LOTS 1 thru 7 and OPEN SPACE LOT 8

SUPPLEMENTAL PLANS

A RESUBDIVISION OF CEDAR ACRES BLOCK A, LOT 12 PLAT BOOK 4, FOLIO 11, 10932 HILLTOP LANE TAX MAP: 35 - GRID: 11 - PARCEL: 41 ZONED: R-SC

TITLE SHEET APRIL 16, 2018 BEI PROJECT NO. 2615

STORMWATER MANAGEMENT DETAILS

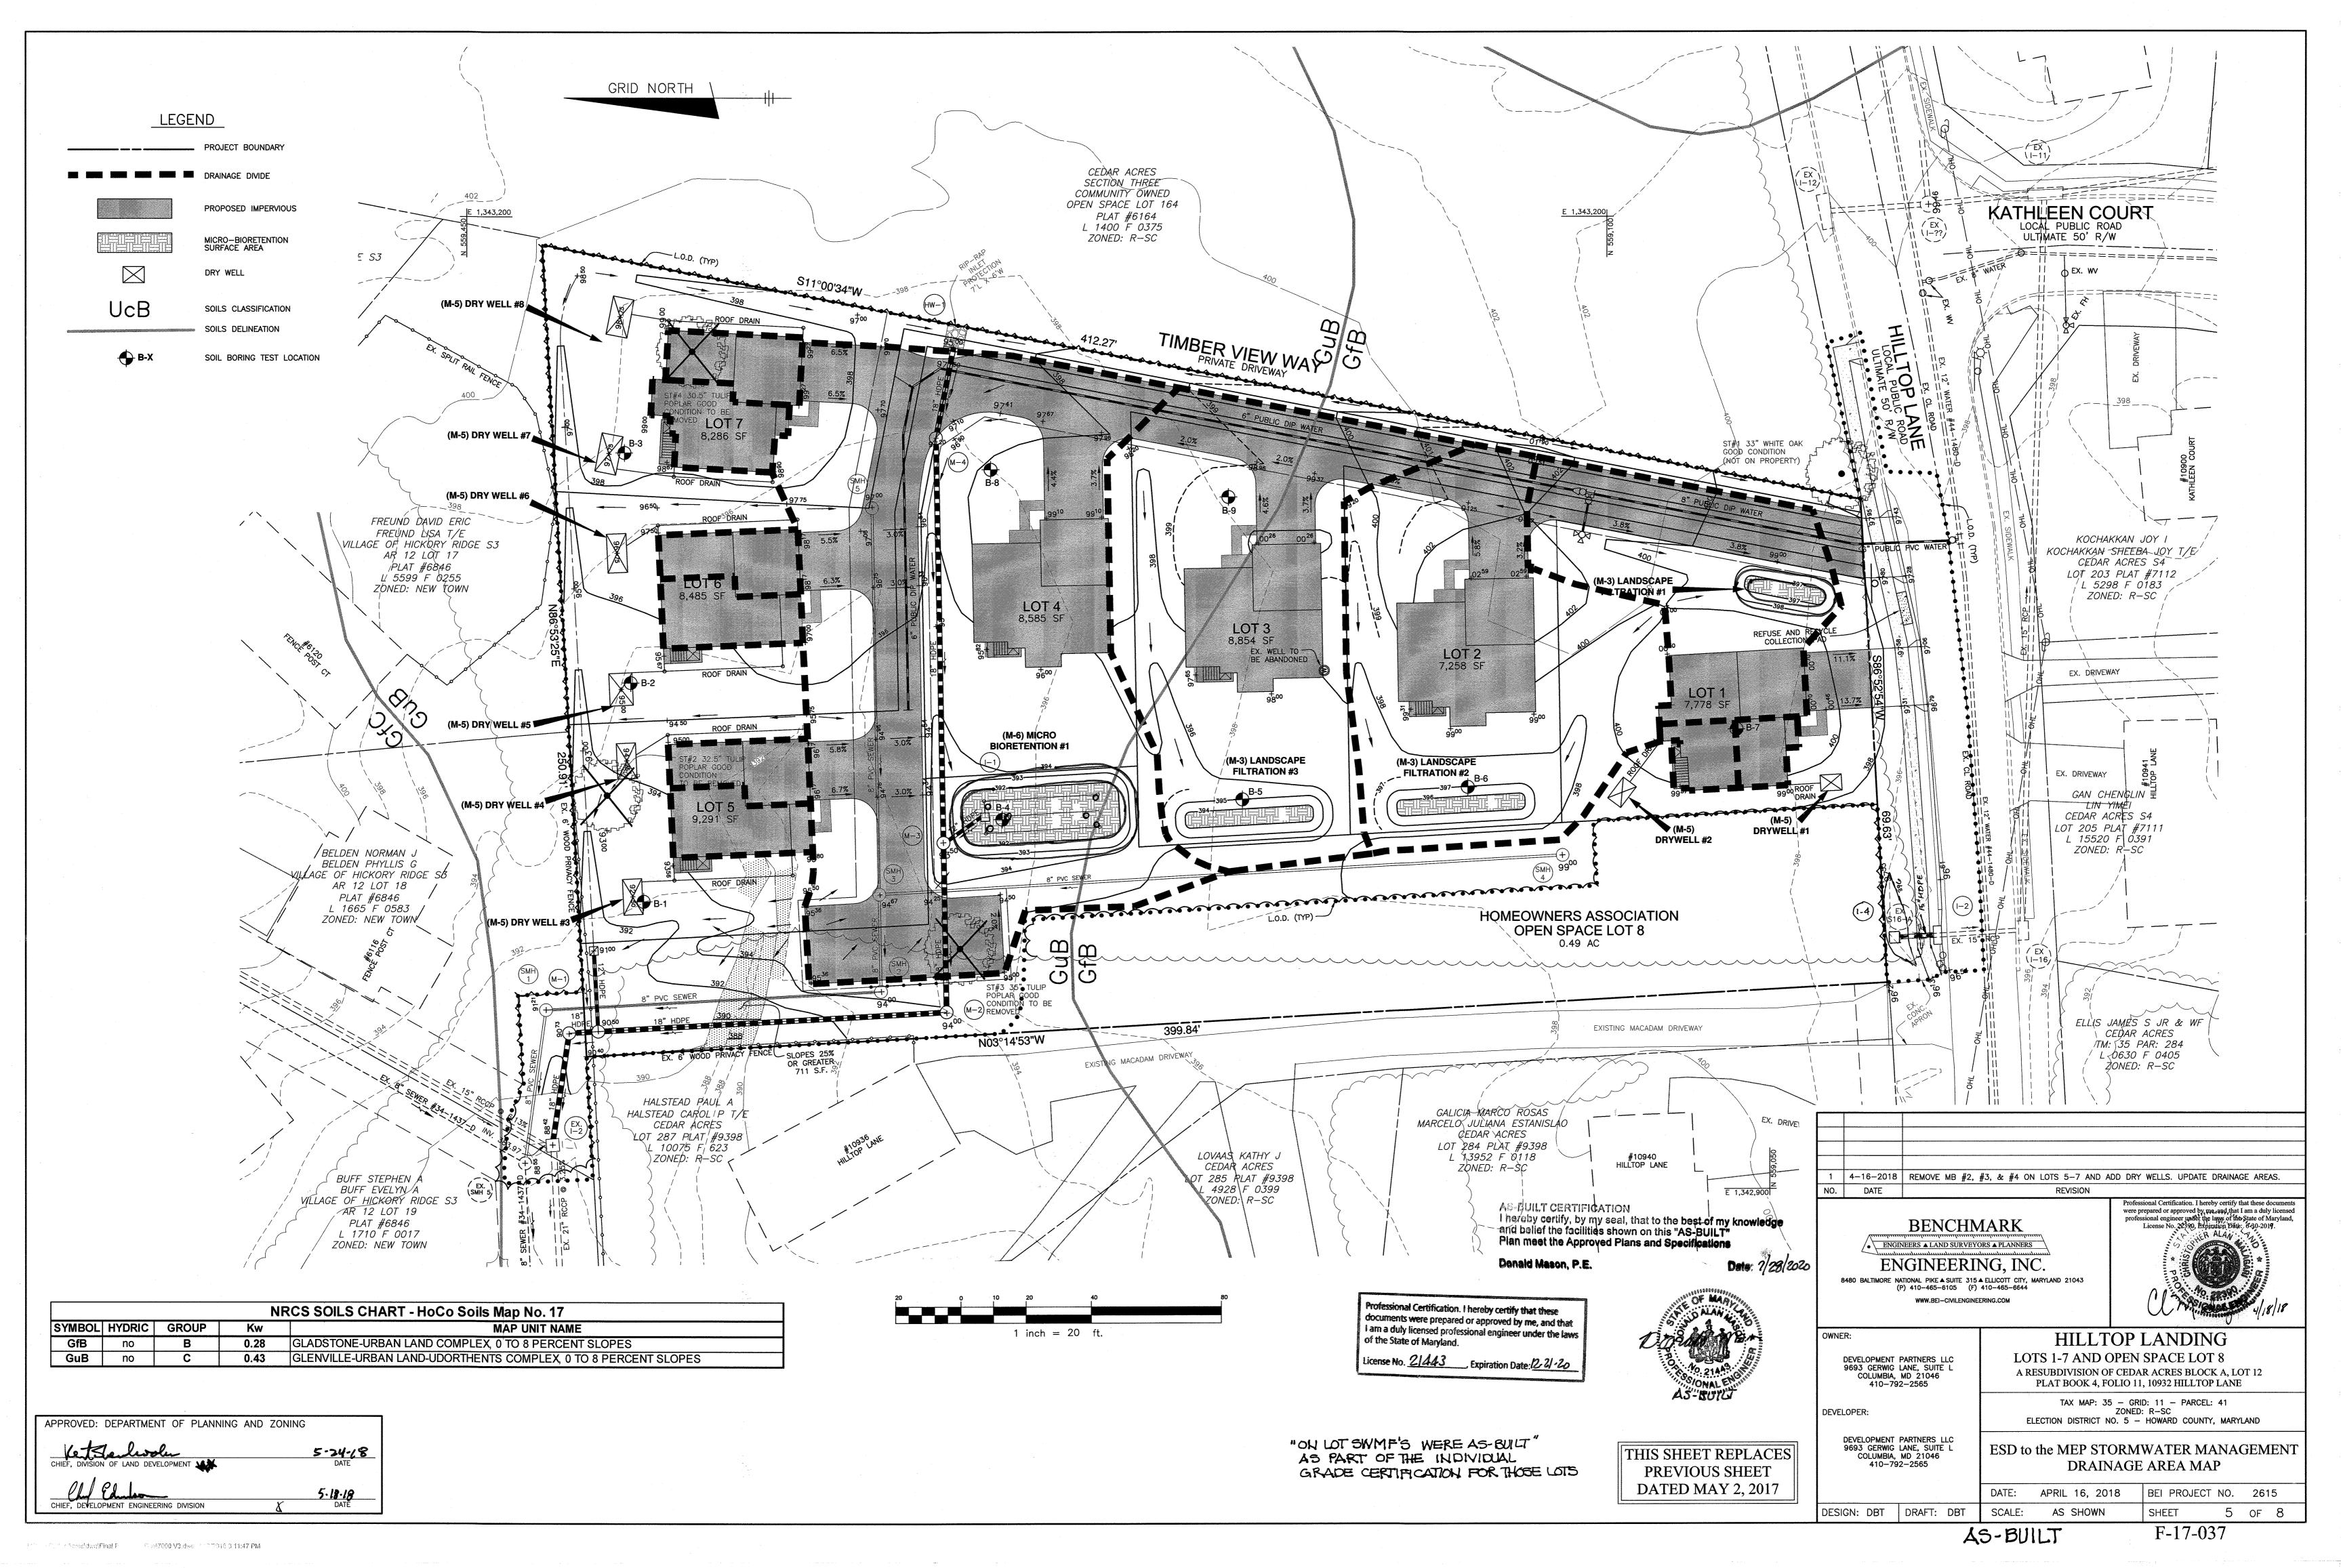
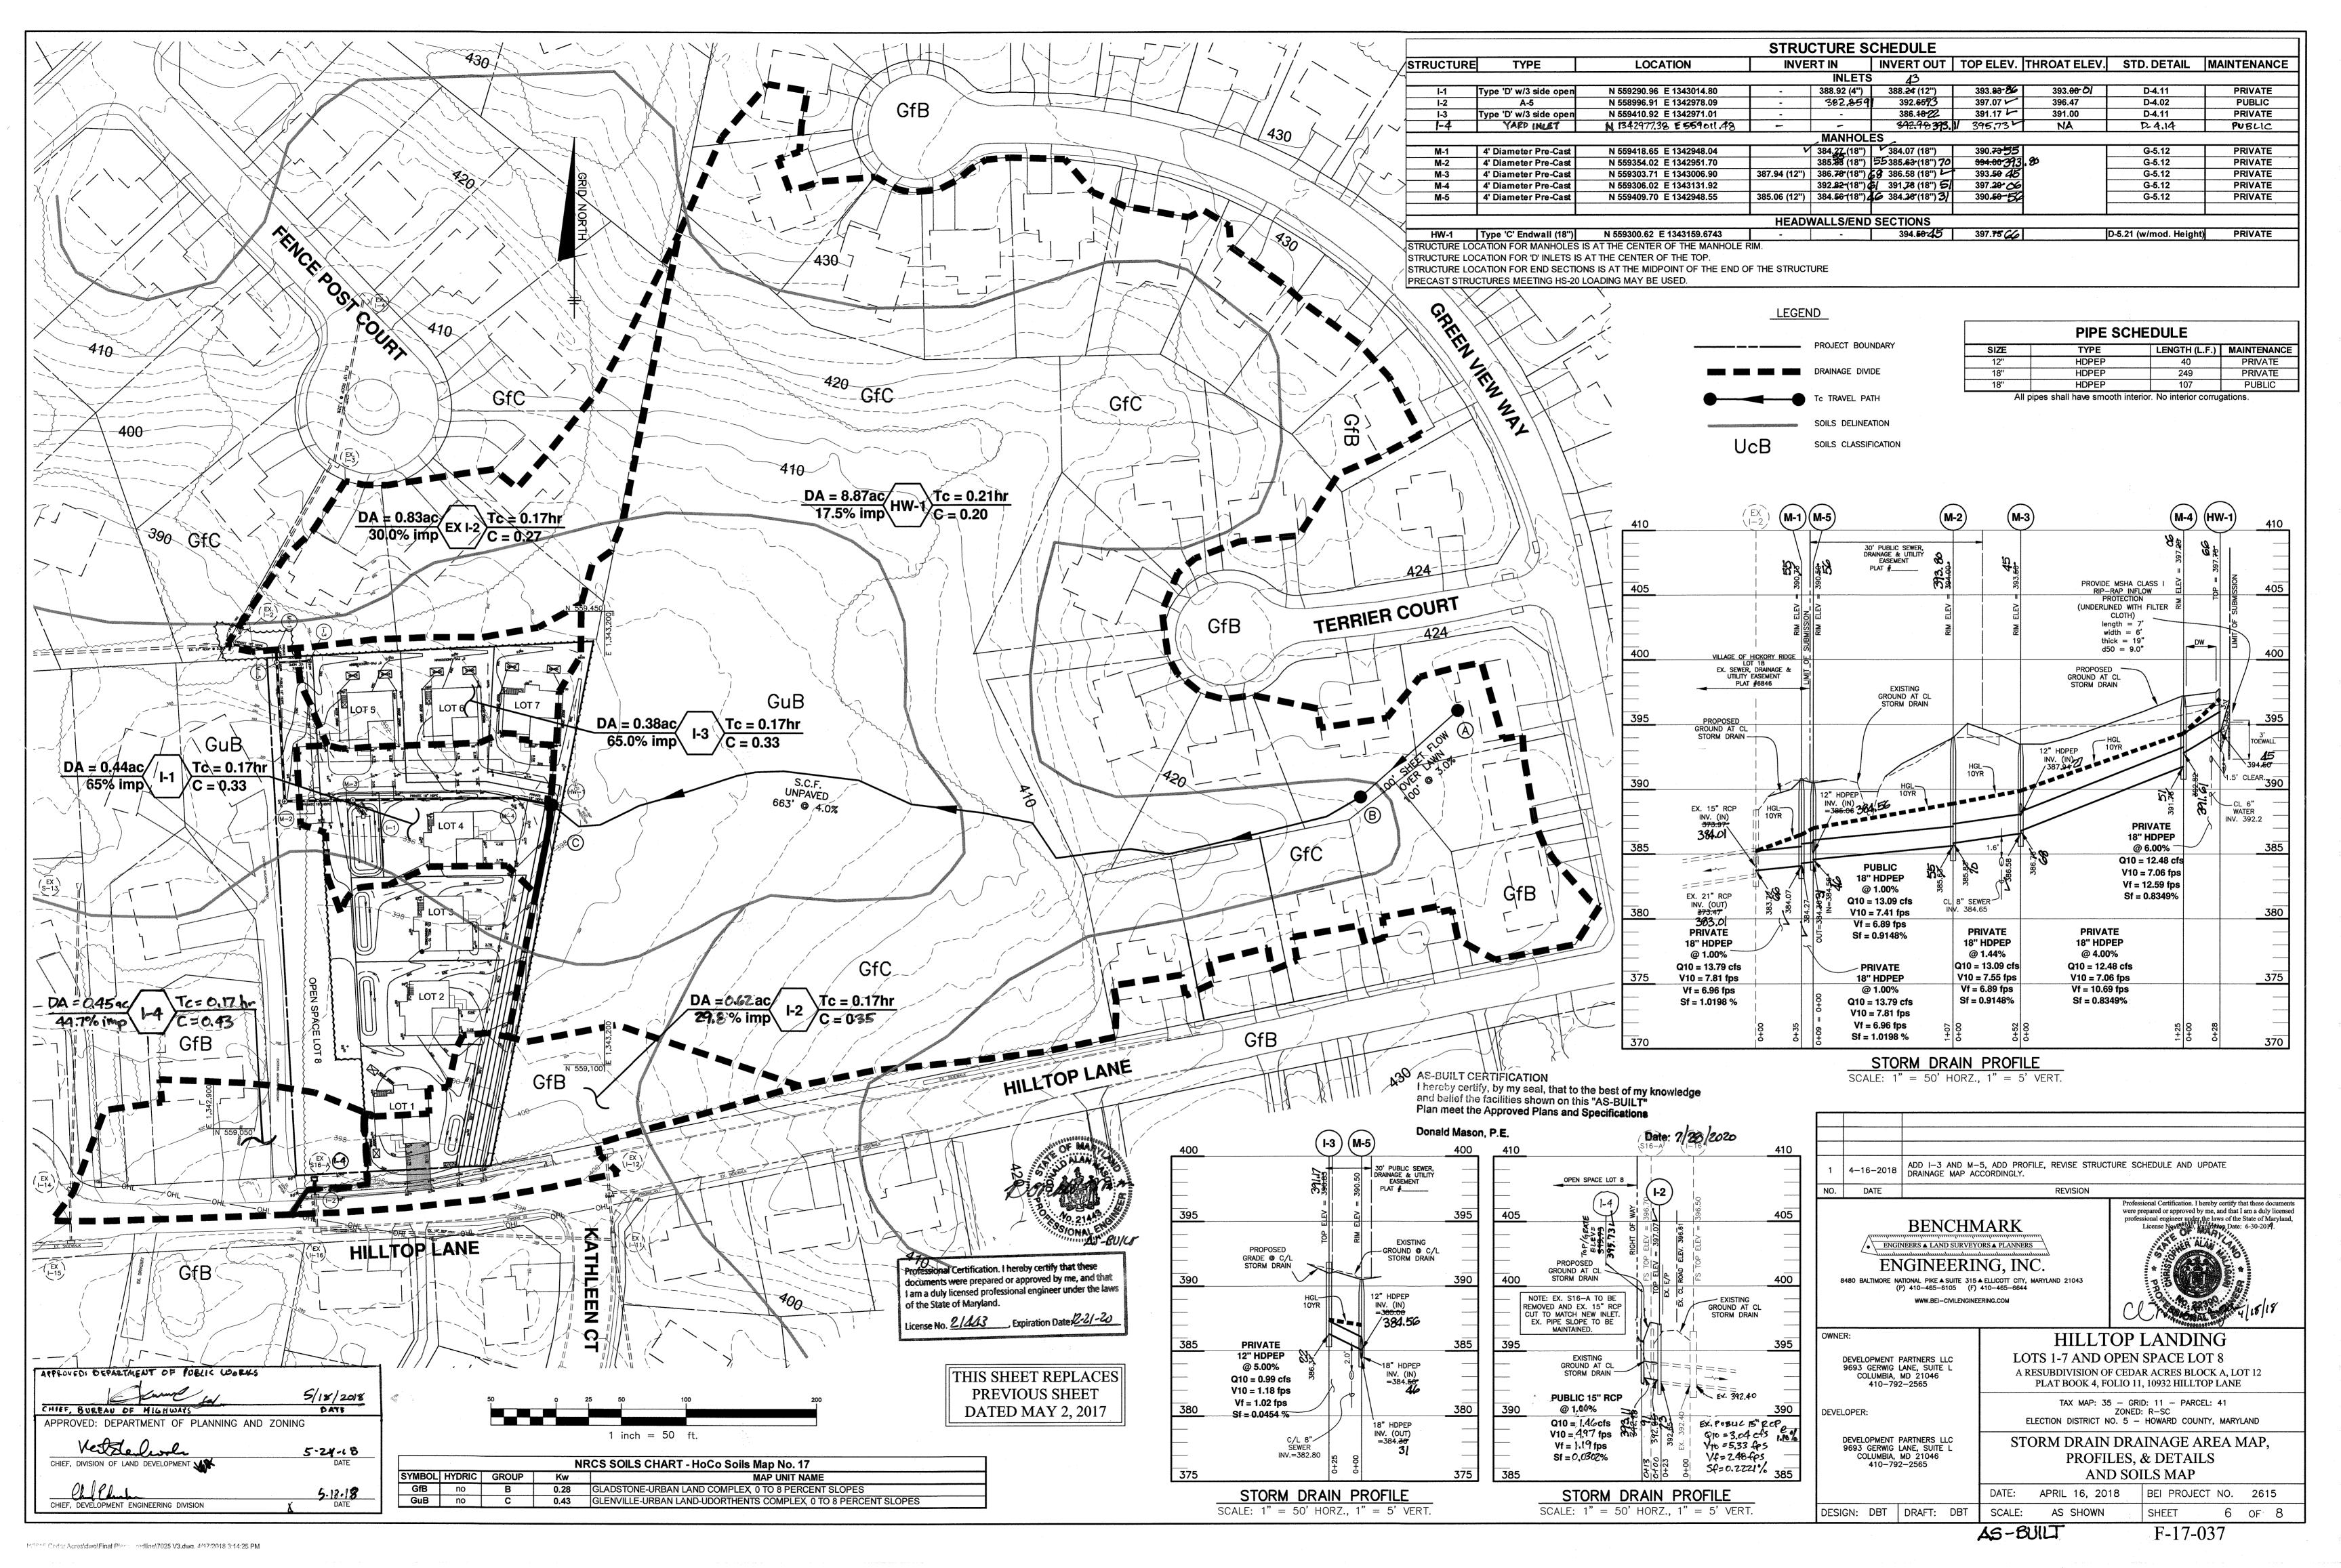
K IHODE MID			1101 10 00/12					
my knowledge .T"	1	4-16-2018	REMOVE MB #2, #ADD DRY WELLS #	#3, AND #4 FROM LANDSCAPE C #3-#8 TO DRY WELL CHART	HART.			
)NS	NO.	DATE		REVISION				
Date: 7/28/2020	٤	ENGINE NA BALTIMORE NA	BENCHM WEERS & LAND SURVEYOR  TOTAL PIKE & SUITE 315 A P) 410–465–6105 (F)  WWW.BEI-CIVILENGINE	DRS A PLANNERS  Administration of the state	Professional Certification. I hereby certify that these documents were prepared or approved by me, and that I am a duly licensed professional engineer under the laws of the State of Maryland, License No. 2390 Exprantion Date. 6-30-2019.			
aat aws 2a		R: DEVELOPMENT F 9693 GERWIG L COLUMBIA, I 410-792	ANE, SUITE L MD 21046	HILLTOP LANDING LOTS 1-7 AND OPEN SPACE LOT 8 A RESUBDIVISION OF CEDAR ACRES BLOCK A, LOT PLAT BOOK 4, FOLIO 11, 10932 HILLTOP LANE
